SEAS DEADLINE 6 RESPONSE to APPLICANTS's SUBMISSIONS
SINCE DEADLINE 5, ISH3, Action Points and ExQ3
LANDSCAPE & VISUAL and CULTURAL HERITAGE

PINS Ref: EN020026
DEADLINE 6: APRIL 13, 2026

EN020026 SEA LINK DCO – DL6: RESPONSE BY NICHOLAS BRIDGES

ZTV ANALYSIS – IP ref FA62B0DA

Figure 10. Sea Link 2023-10 PEIR Volume 3 Part 2 Chapter 4 Figures A Heritage & Landscape with ZTV, page 24 [Drawing 4 of 6]
DESIGNATED ASSETS WITHIN THE 2KM STUDY AREA ALONG WITH THE ZTV FOR CO-LOCATION AND FRISTON

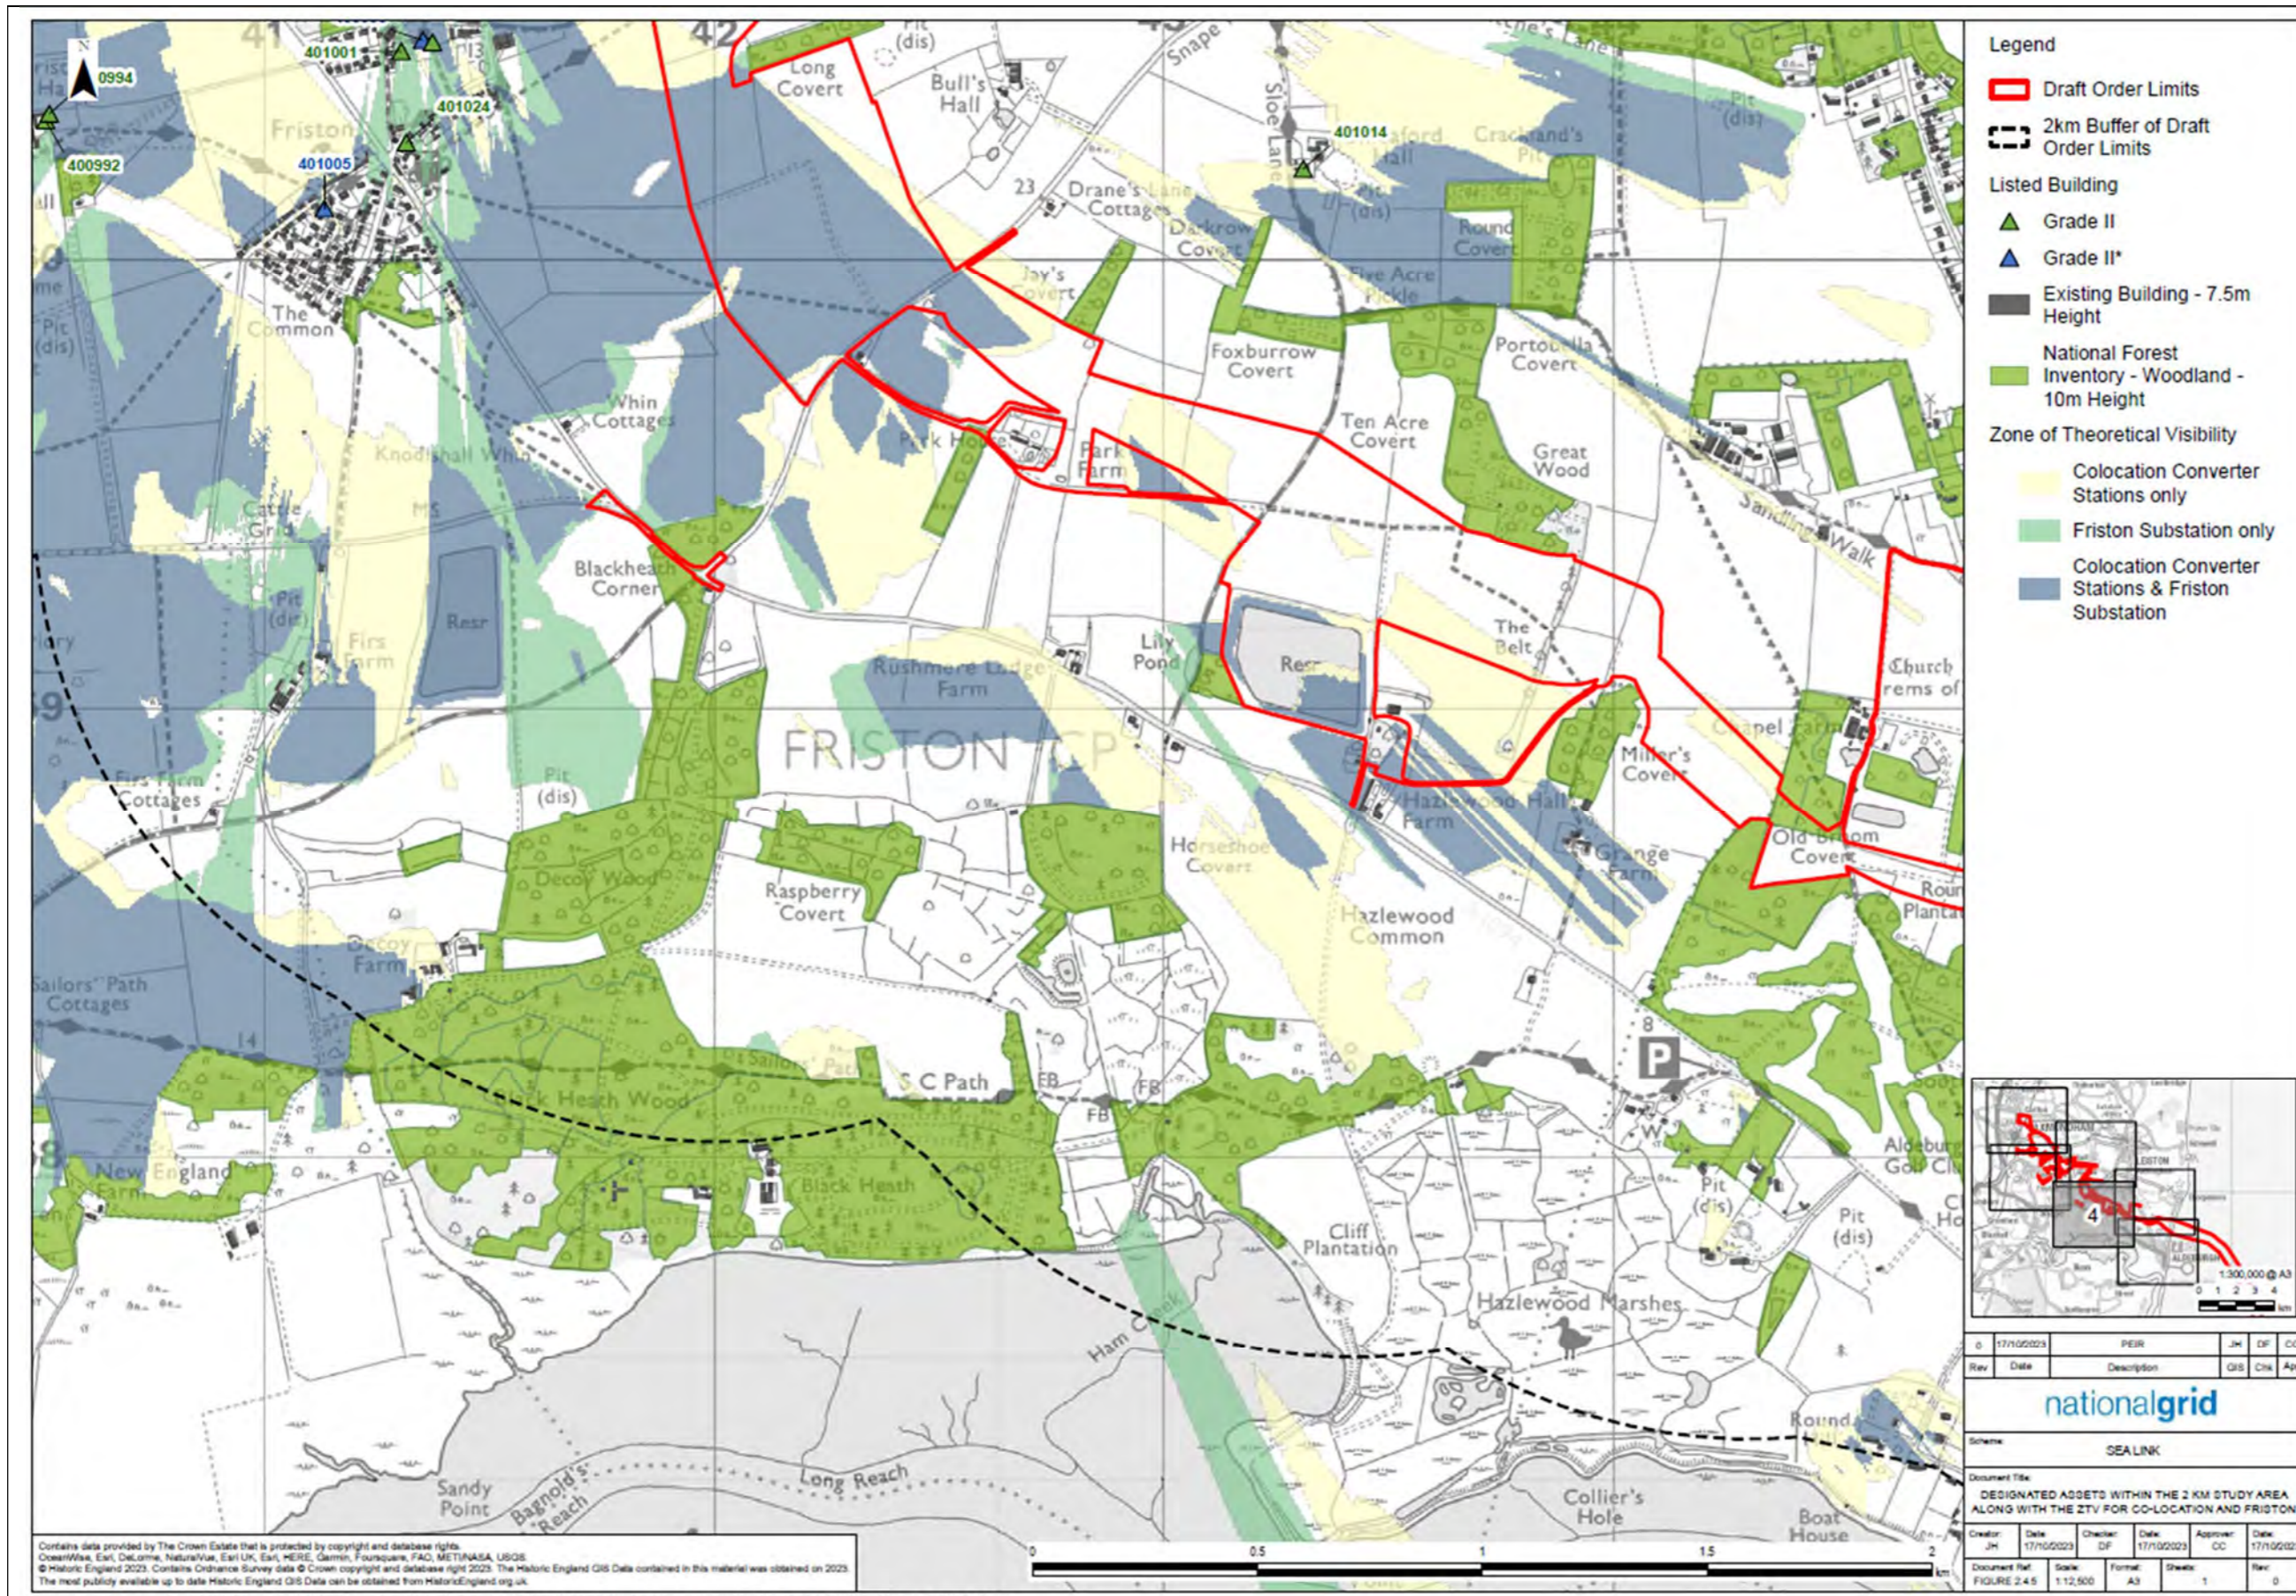
2.9. The ZTVs of the two Friston projects and Sea Link's PEIR have a similar pattern of visibility around their projects (see **Figures 1 to 11** below). Sea Link includes the National Grid substation at Friston which each of EA1N and EA2 also included. All Projects were modelled using OS contours, woodland and buildings at a generic height. Observer heights were a little higher for EA1N and EA2. The two Friston substations used the same parameter model as Sea Link.

2.11. The **first question** is: why are the PEIR and DCO plans so completely different? Were the heights in the model changed? Were the shadowing criteria altered? Which is correct? If the DCO is correct, were the EA1N and EA2 ZTVs incorrect? These are simple technical points which can be explained easily.

2.19. The Sea Link ES LVIA decided not to extend the coverage of its ZTVs when its PEIR had already revealed visibility of the
